Our ref: DOC20/881350

Senders ref: SSI-10051

Subject: EES comments on Environmental Impact Statement for Sydney Metro - Western Sydney Airport Project – SSI-10051 – St Marys to Western Sydney Aerotropolis Core precinct

Source: extract from Figure 3.1 of EIS shows surface alignment near Patons Lane (see red arrow) and the location of the east-west regional corridor linking across from the Orchard Hills defence land to South Creek

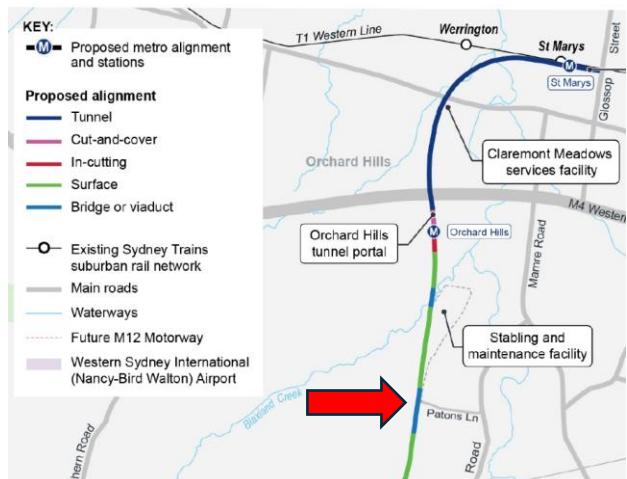
The rail alignment crosses the east-west corridor east of the Orchard Hills defence lands near Patons Lane and has the potential to sever the corridor linkage between the defence lands and South Creek if it is constructed at the surface and/or is not designed to maintain and improve connectivity (see extract below from Figure 3-1, page 3-2 in the EIS). The SSI should not sever the east-west corridor and should be designed to either incorporate an appropriate bridge or viaduct crossing or tunnel under the corridor.

Figure 3.1 in the EIS indicates the rail alignment is proposed to be constructed at the surface near Patons Lane while Figure 7-1 shows a bridge or viaduct is proposed to be constructed (page 7.3) and Table 7-2 indicates a viaduct is proposed to cross Patons Lane and the unnamed tributary of South Creek at this location. The RtS needs to confirm if the rail alignment at Patons Lane will be constructed at the surface, or if a bridge or viaduct is proposed. It is important the SSI protects and improves corridor connectivity at this location to enhance the regionally significant east -west corridor connection.

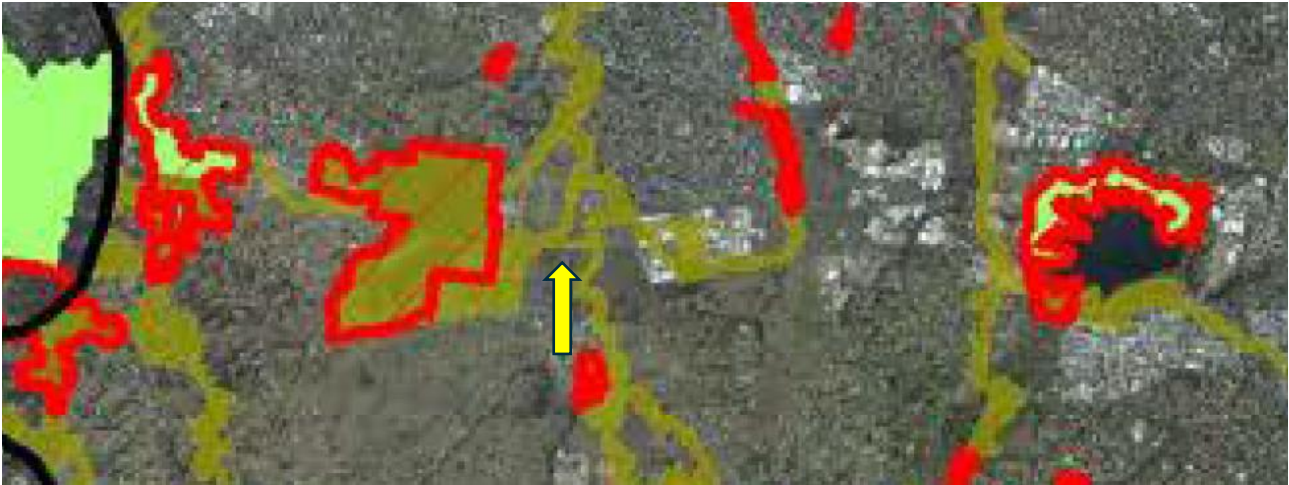
As SSI-7127 plans to improve connectivity between the Mulgoa Nature Reserve and the Defence Establishment Orchard Hills, it is important that both the Stage 5 upgrade of the Northern Road and the Sydney Metro - Western Sydney Airport project protect and improve connectivity along this east-west regional corridor.

Source: extract from Figure 7.4b of EIS

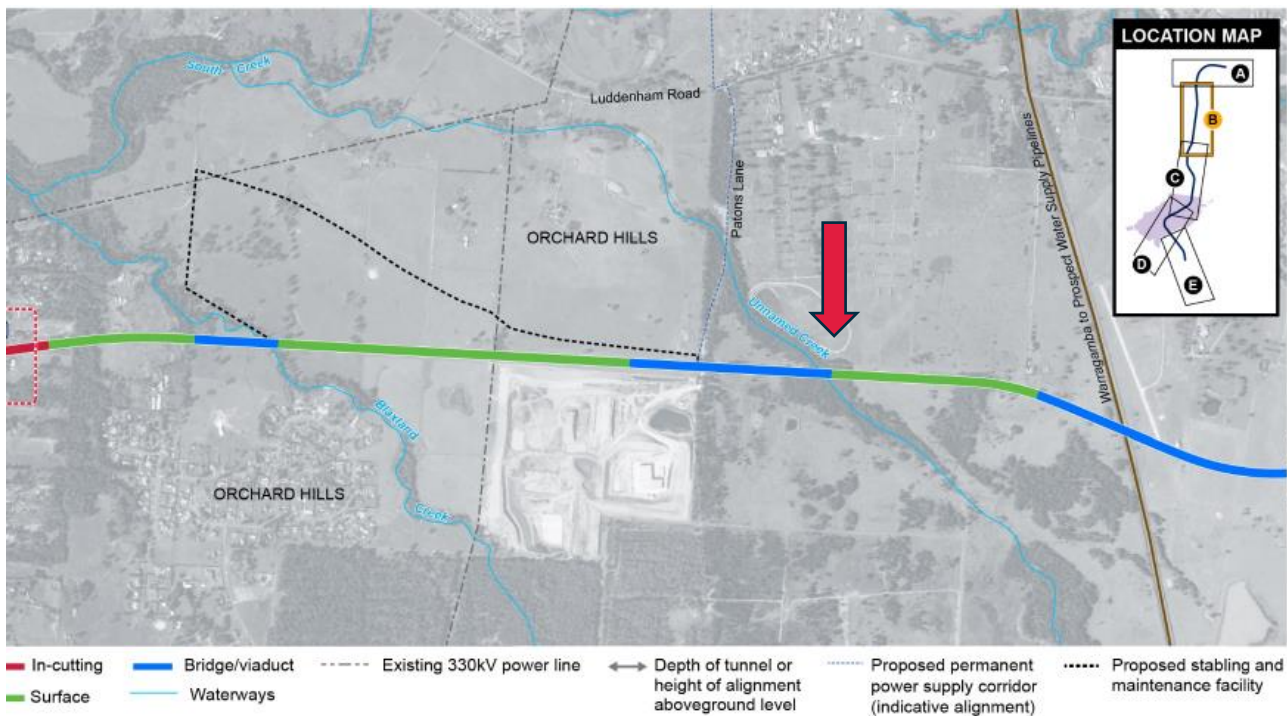
Figure 7.4b shows that part of the proposed bridge/viaduct near Patons Lane would be located over cleared land beside an existing quarry but the length of the bridge/viaduct does not extend to protect all of the existing remnant vegetation along the unnamed tributary of South Creek (see extract of figure below and red arrow).

The structure should preferably be longer in length and/or located to protect all the remnant vegetation. The bridge/viaduct structure should minimise the clearing/disturbance of existing native vegetation, maintain and/or improve connectivity under the structure to maximise the corridor function. It should be elevated and span the full width of the corridor and/or remnant native vegetation which-ever is the widest to avoid or reduce the need to clear and/or disturb remnant native vegetation. The RtS should provide further details on this.

Source: extract from Figure 3.1 of EIS – green dashed line shows the tunnel could potentially pass beneath Shanes Park

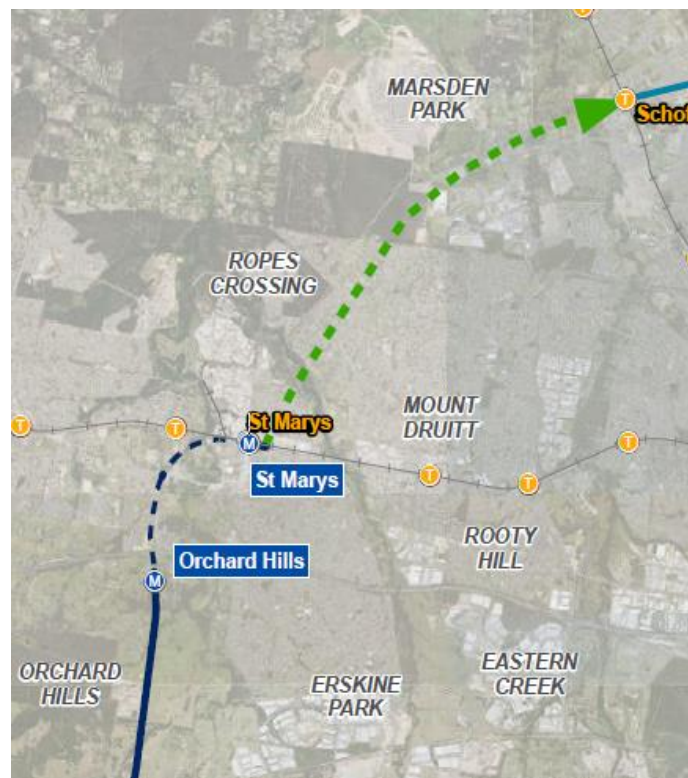
Figure 3.1 in the EIS shows the potential north-south extension from St Marys to Schofields (see green dashed line in the figure below). It appears the proposed tunnel could potentially pass beneath Shanes Park (Lot 1 DP447543).

The proponent needs to clarify that the dashed green line shown in Figure 3.1 is a tunnel to ensure there is no surface infrastructure proposed to be in Shanes Park (such as surface rail alignment, vents, tunnel infrastructure etc).

Noting the rough estimation of the tunnel's location, EES' and NPWS' preference would be to see the tunnel not located beneath the park, and certainly no surface impacts. It would appear little deviation of the proposed route would be required to achieve this.
